ENGINE SYSTEMS, INC.

Subject: 10CFR21 Reporting of Defects and Non-Compliance -
Engine Systems, Inc. Report No. 10CFR21-0118, Rev. 0

Speed Switch
PNs ESI50267C, ESI50267E, ESI50267H, and ESI50267K

**10CFR21 REPORTING OF DEFECTS
AND NON-COMPLIANCE**

Photo 1: View Showing Capacitors C1 through C8

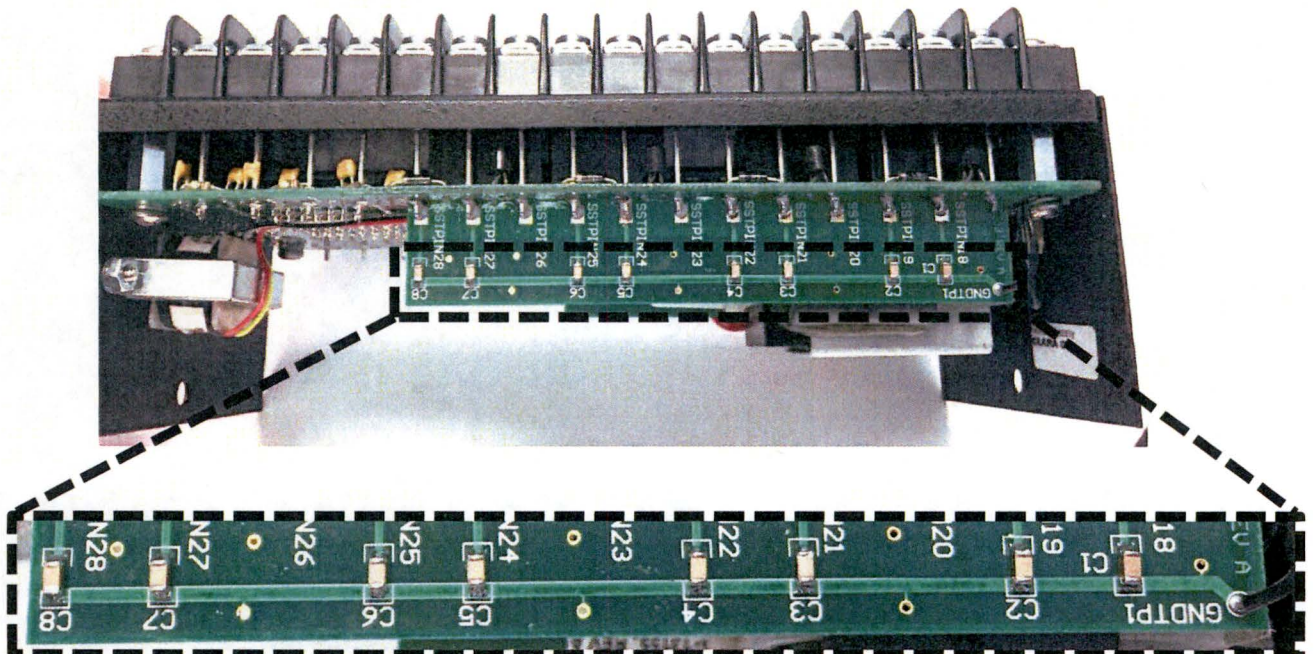
This speed switch design is fully EMC compliant in accordance with EPRI TR-102323, rev.3. In order to meet the EMC requirements, some design modifications were made during the EMC qualification. One of these modifications was the addition of eight (8) capacitors, C1 through C8, installed from Normally Open-to-Ground and Common-to-Ground for the speed switch's relay output contacts (the switch has four relays). See Photo 1 below and Figure 1 on the following page showing location of capacitors. The modifications utilized for EMC compliance were incorporated into the speed switch design by the OEM and offered as a unique part number SST2400A-416.

The failed speed switch at Hope Creek was sent to Exelon PowerLabs for analysis. It was determined that capacitor C4 (terminal 22 to ground) had degraded and exhibited a low-resistance path to ground. Capacitor C4 is rated for 200 VDC working voltage and has a withstand voltage of 500 VDC. Further investigation revealed that although the nominal system voltage is 120 VDC, the customer's external relay coils that are connected to the speed switch output contacts do not have transient suppression, such as with a flyback diode. In these cases, the voltage transient produced when de-energizing the relay's coil is large enough to damage the capacitors. Hope Creek recorded a voltage spike exceeding 1467 VDC.

- (1) For those customers that have transient suppression across the associated relay (i.e. VSR or ESR relays at the Exelon plants), there is no negative impact. The speed switch will operate properly in this system.
- (2) For those customers that do not have transient suppression across the associated relay (i.e. CRR, ASR, LSR, and HSR at Hope Creek), this speed switch design is not appropriate for their system. Any speed switch(es) that are installed should be removed from service.
- (3) ESI is currently evaluating options for re-designing the speed switch while maintaining the EMC compliance desired by many customers. This evaluation is underway and is expected to be complete within 60 days.

Figure 1: Schematic Representation of Capacitors Installed on Relay Output Contacts

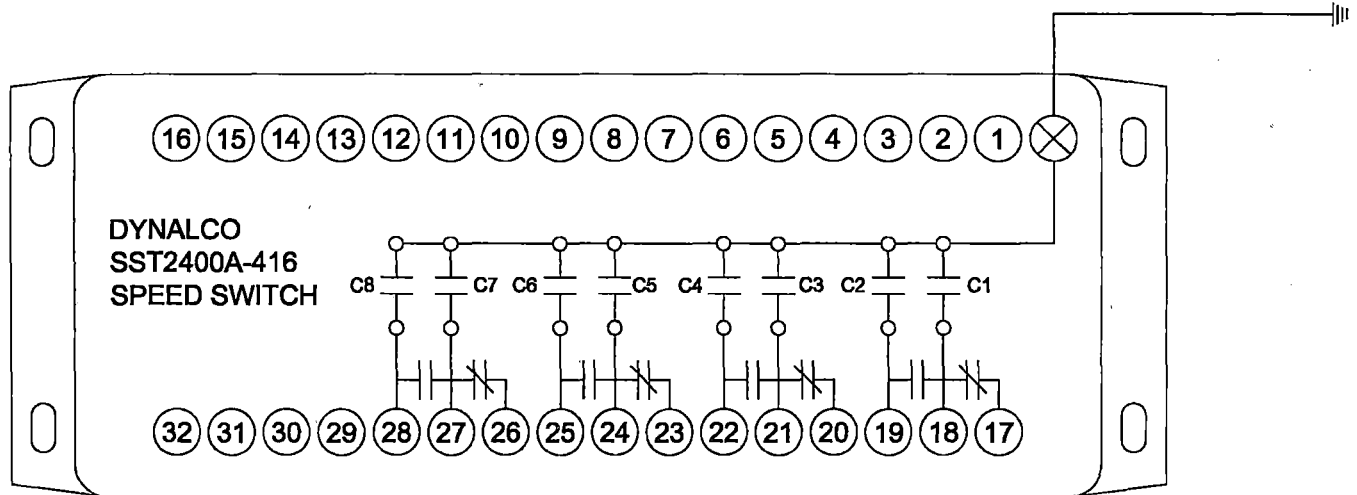
The root cause of the failure is a deficiency in the design and selection of the EMC mitigating components. Consideration was not given for the impact of voltage transients imparted on the capacitors during coil de-energization. For customers without suppression from the inductive kick, the magnitude of voltage transients may be sufficient to damage and ultimately degrade the capacitors to the point of failure.
